**Re: #09ITB1102K-JD North Service Center Renovation 7741Roswell Road**

**#09ITB1102K-JD North Service Center Renovation 7741 Roswell Road**
**Addendum No. 2**

This Addendum forms a part of the contract documents and **modifies** the original ITB documents as noted below:

1 A-3.2 DOOR ELEVATION
SCALE: 1/4"=1'-0"

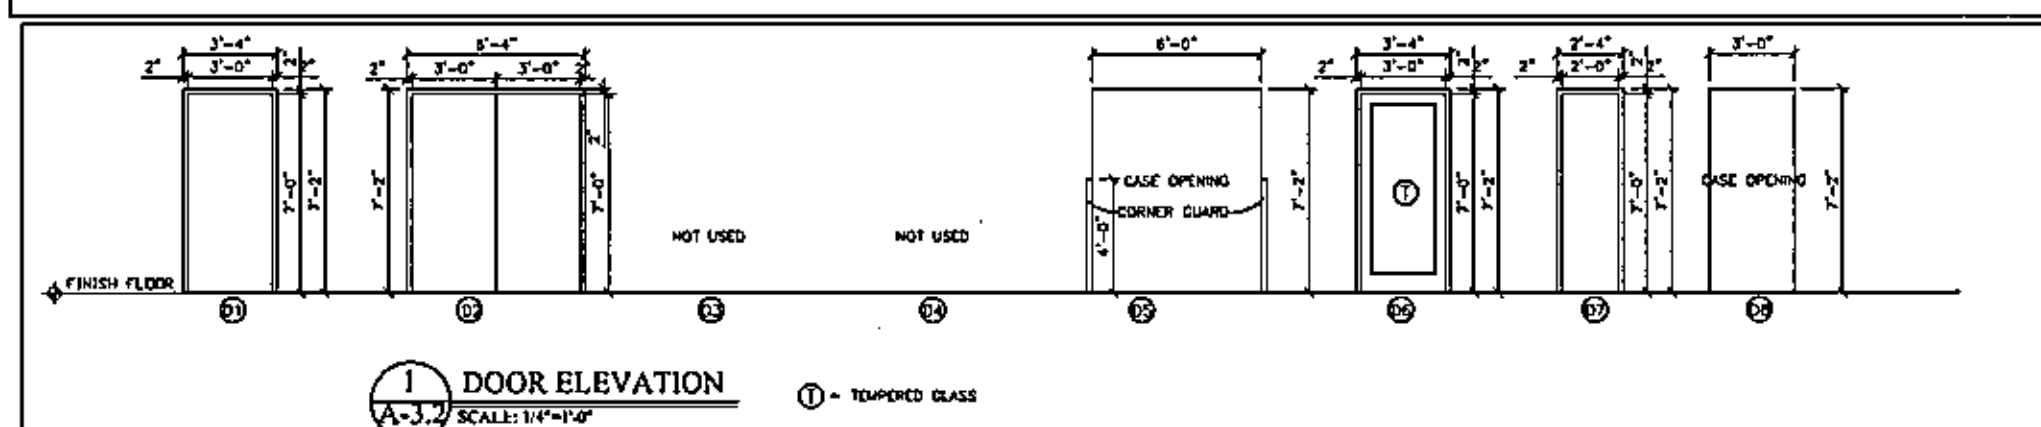
4. Door # 197.2 is shown on the door schedule as a wood door with a hollow metal frame. This appears to be an exterior opening and I'm thinking it should be an alum door & frame. Please verify.

23. Door #197.2 located at the exterior building front calls for a HM frame and a wood door in the door schedule shown on sheet A-3.2 and elevation F5 on sheet A-3.1 calls for an aluminum frame on the window schedule. Which is correct?

Answer: Door 197.2 is to be an aluminum door and frame.

Answer: Door 197.2 is aluminum with an aluminum frame.

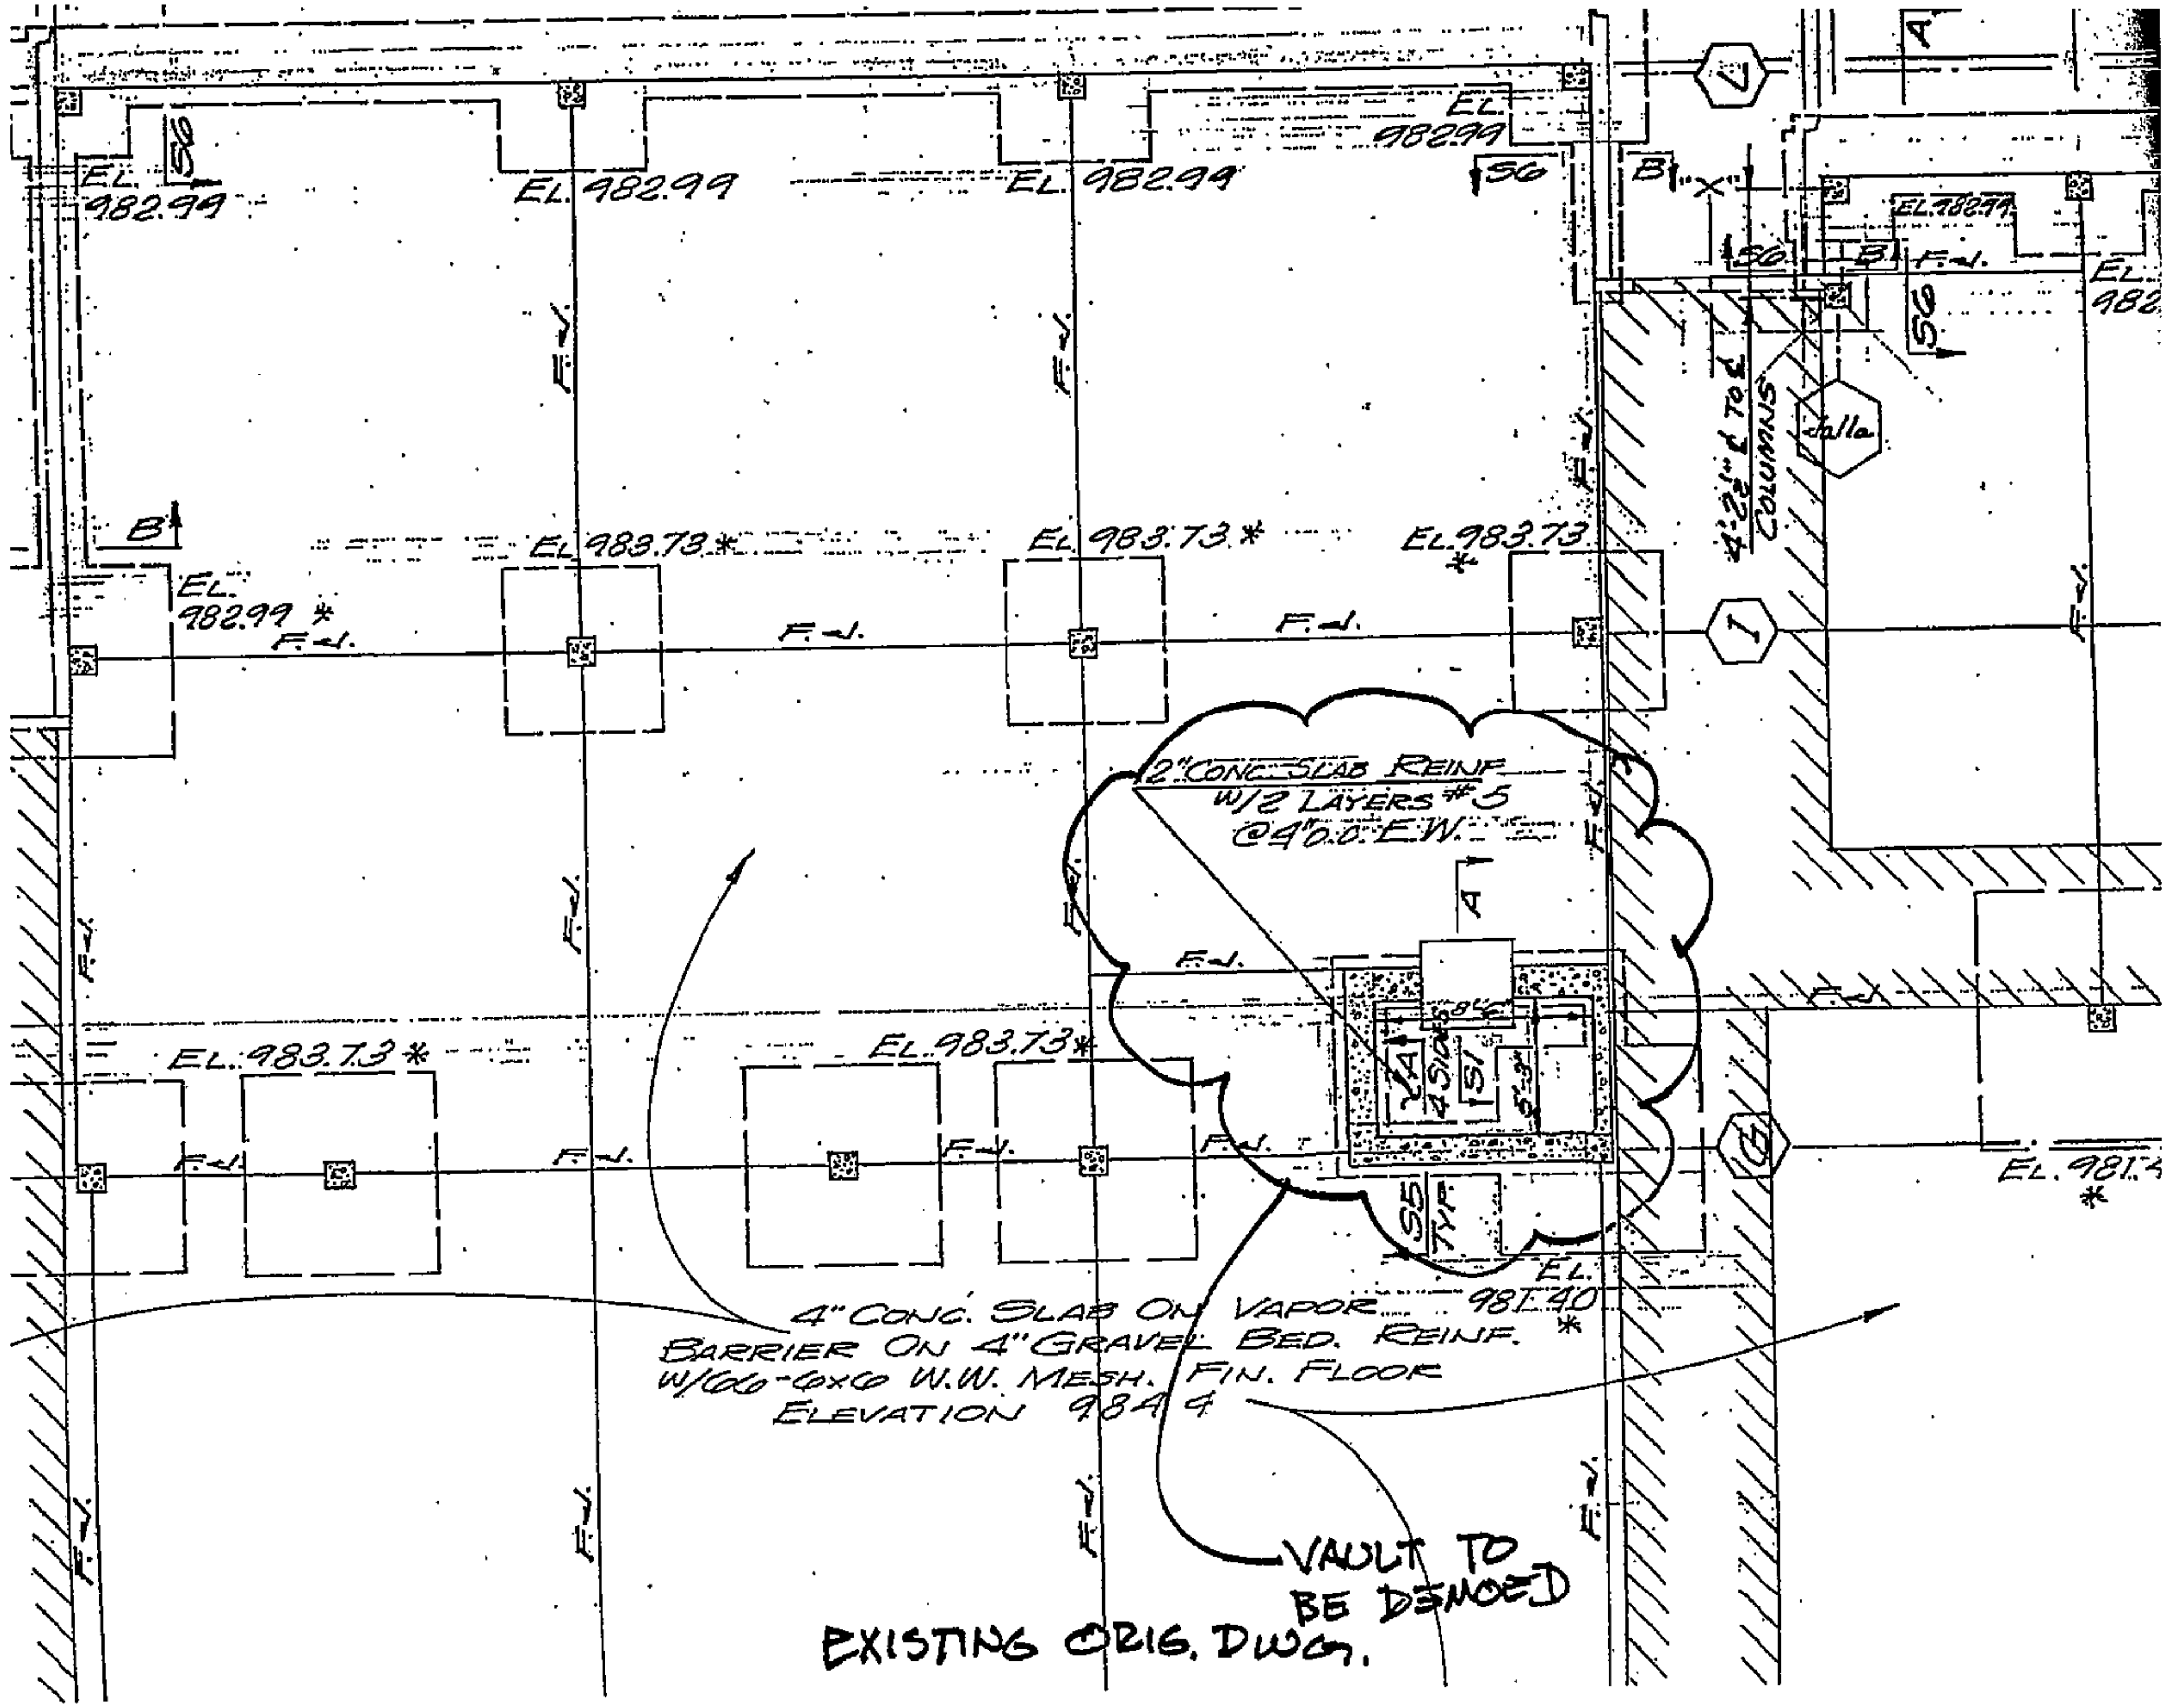
18. Please provide existing building as built specifications regarding rebar placement and size within: poured in place concrete walls scheduled for demolition, vault shown for demolition, second floor slab at areas of slab penetration.

19. Regarding the concrete walls and vault slated for demo, is the rebar integrated with the floor slab?

Answer: See Attachment B of this addendum.

Answer: See Attachment B of this addendum.

HOLDING CELLS TO BE DEMOLISHED EXISTING DWG.
4'-2½" ℄ TO ℄ COLUMNS
EL. 982.40
EL. 982.00
EL. 982.99
EL. 982.19
EL. 982.19
EL. 982.19
EL. 982.99
EL. 982.99
EL. 982.99
7"
7'-5"
19'-8½"
4'-8½"
7'-5"
7'-10½"
16'-10"
6'-3"
25'-7"
6'-3"
25'-10½"
60'-7½"
114'-2½"
F
Fa
G
H
Ha
I

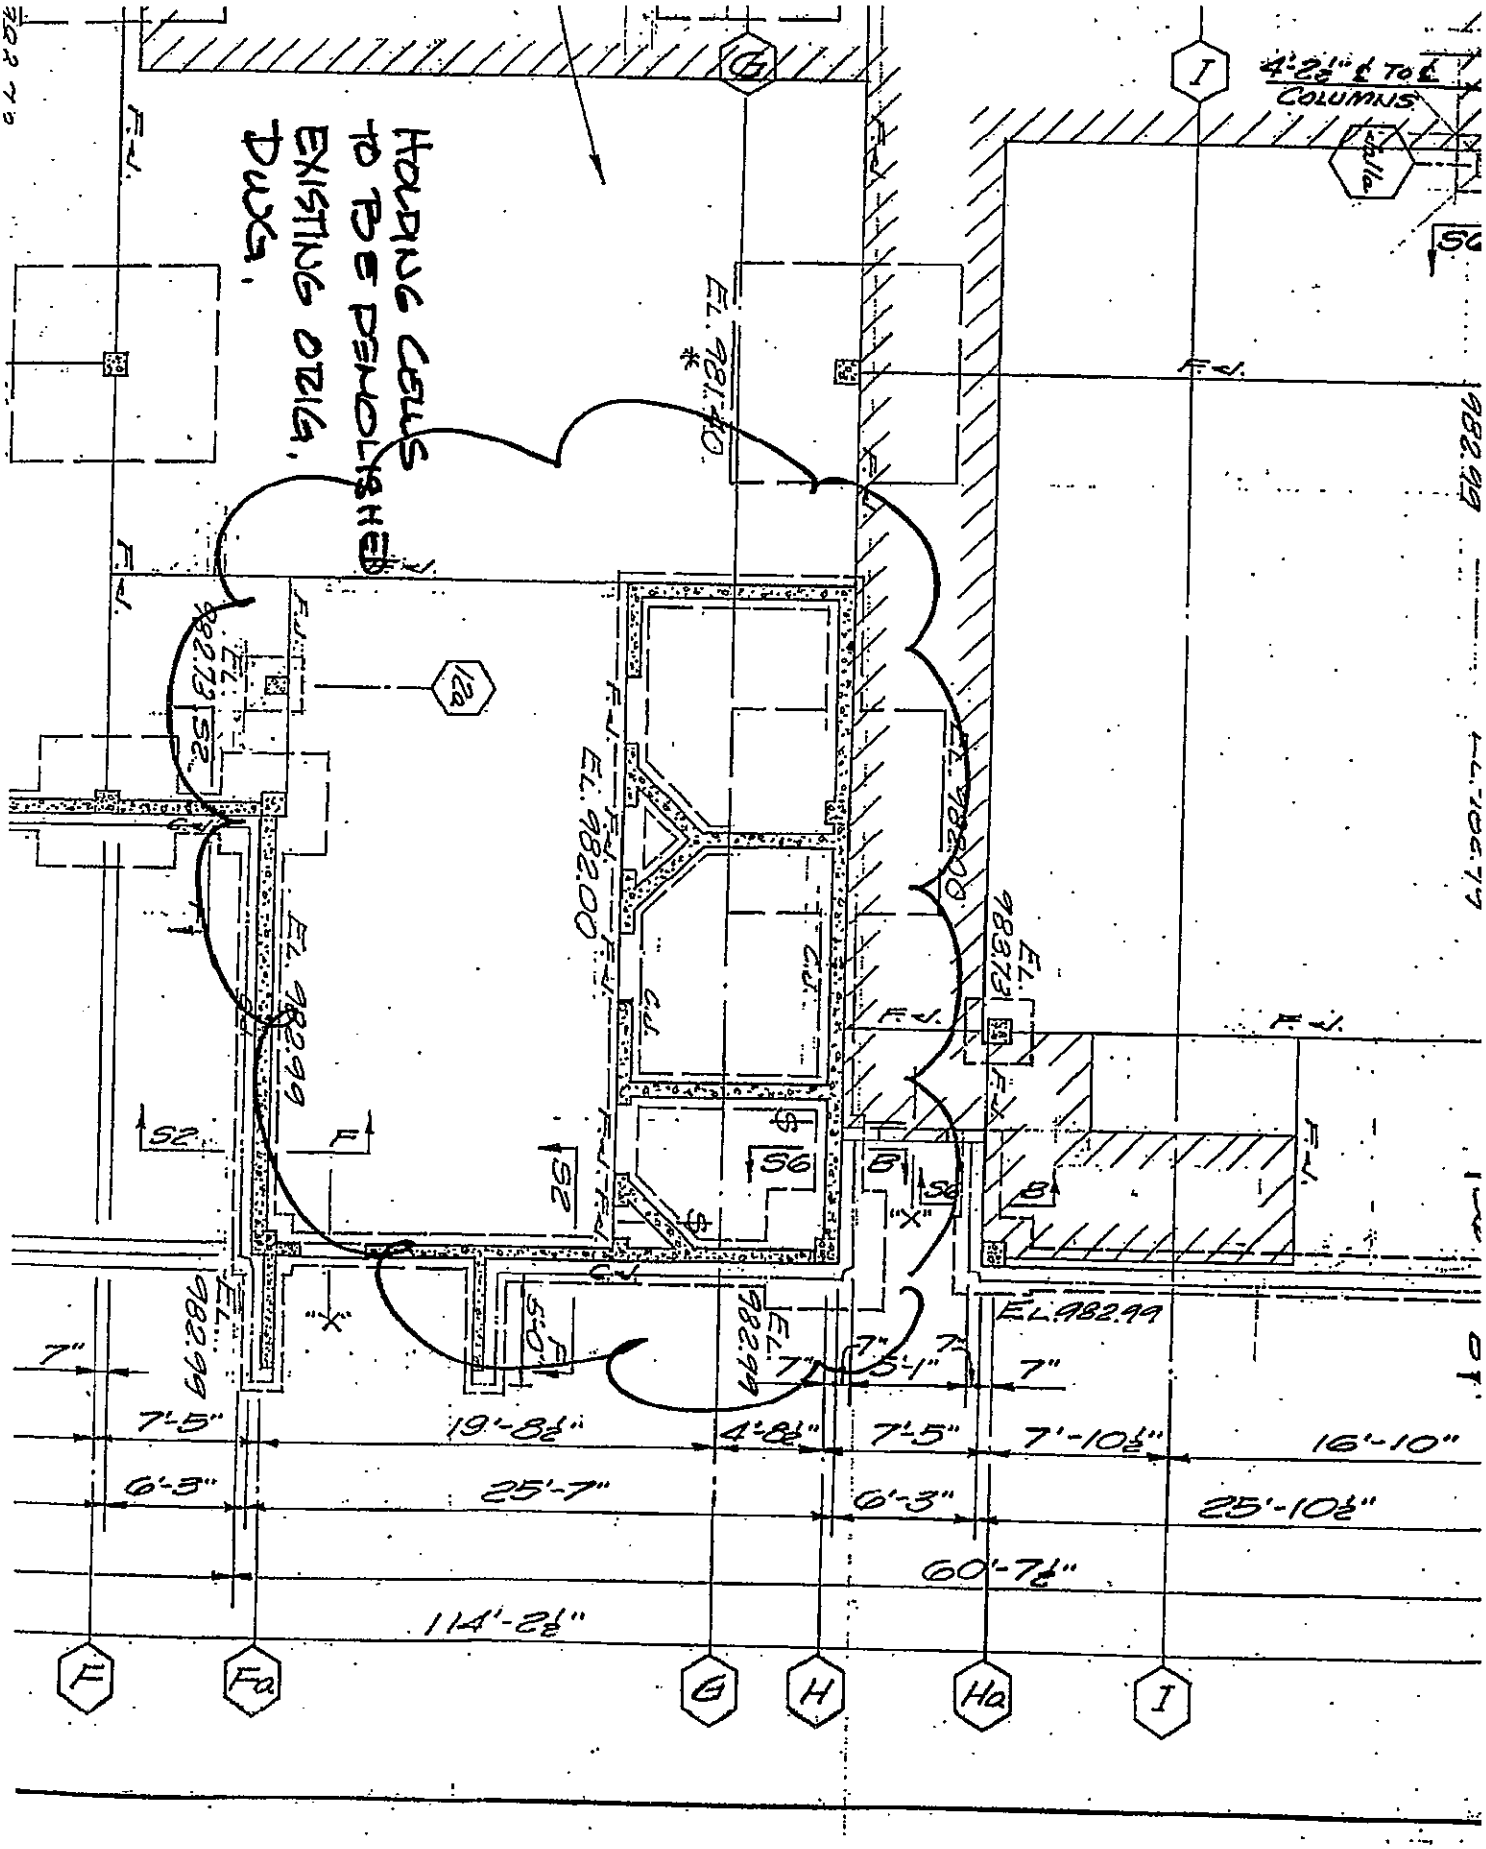
21. How are the existing holding cells constructed? Please provide details of the existing construction. Are there additional security items not visible such as steel plating or mesh? If so, thickness and type? Where located? Walls, ceilings, floors, benches?

Answer: See Attachment B of this addendum.

HOLDING CELL SECTIONS
EXISTING ORIG DWG

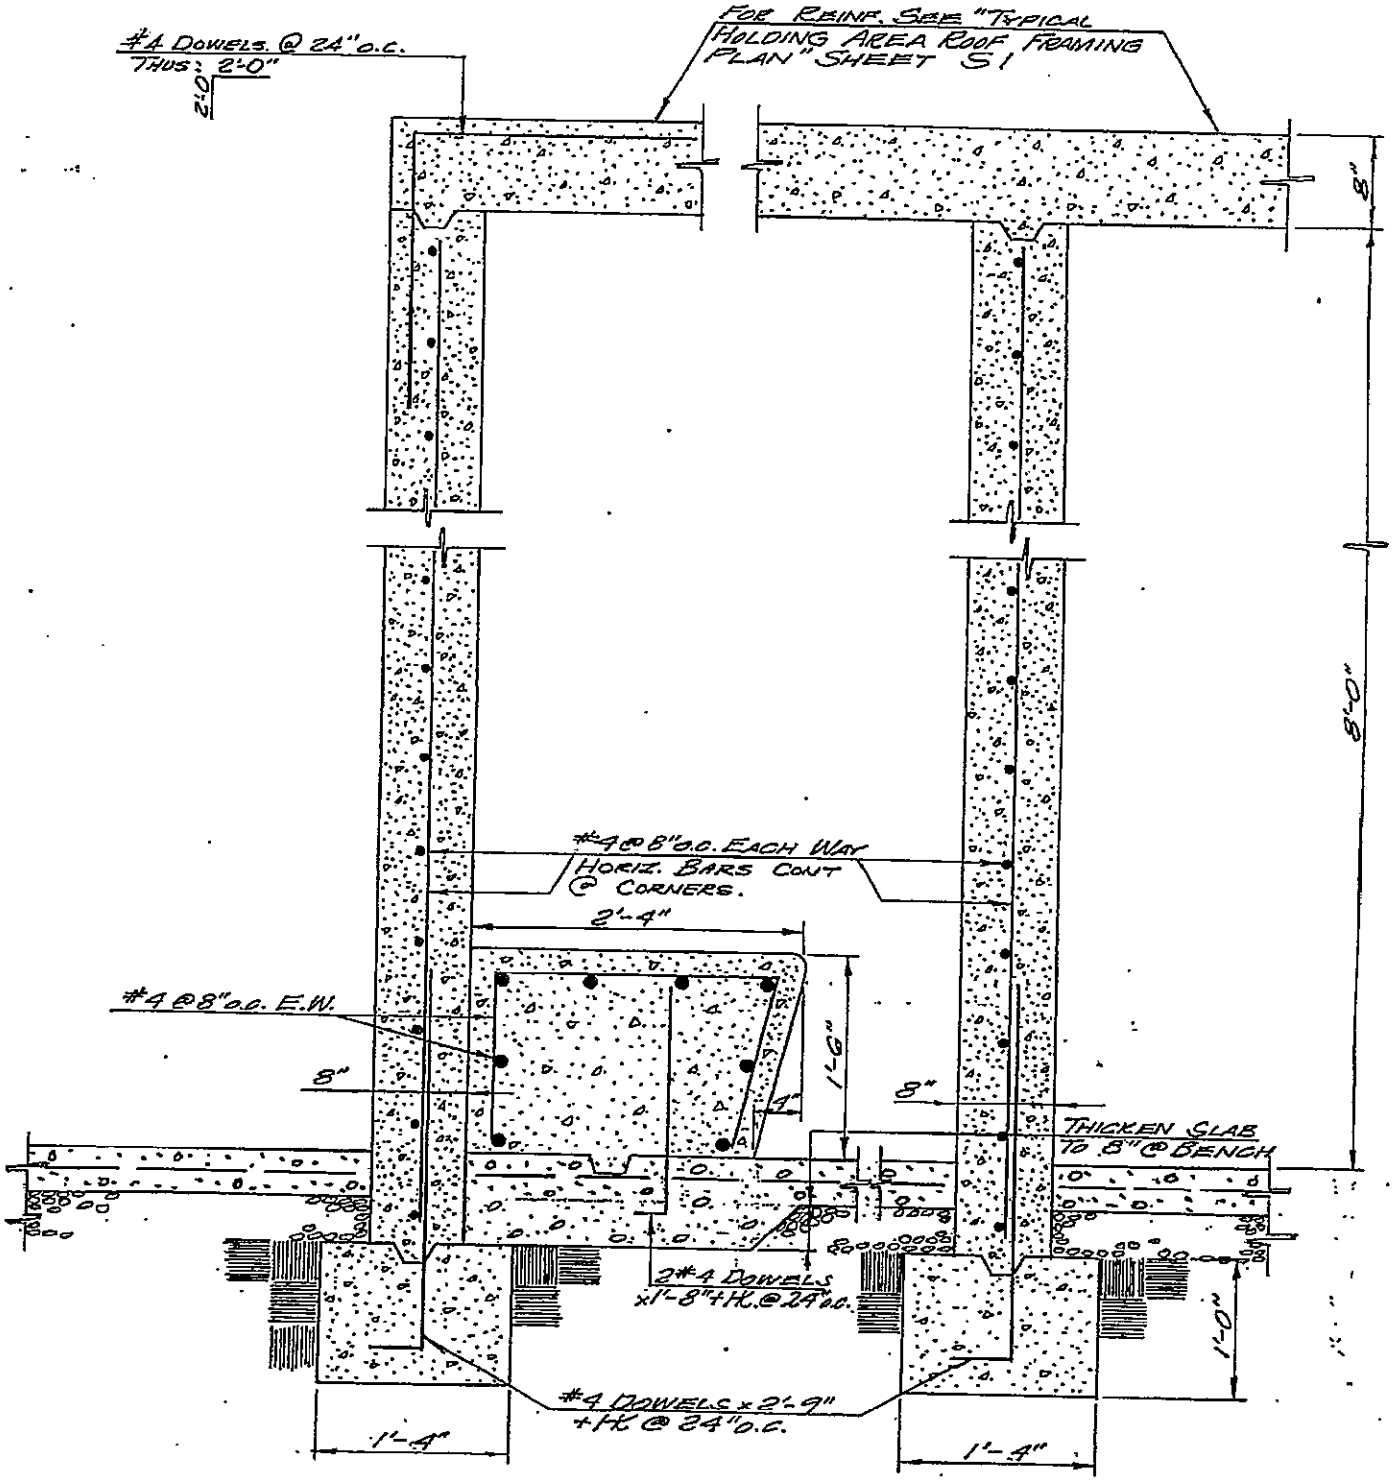
20. Are the cells of the CMU walls scheduled for demolition grouted? Do they contain rebar? If they contain rebar, what is the placement and size?

Answer: See Attachment B of this addendum.
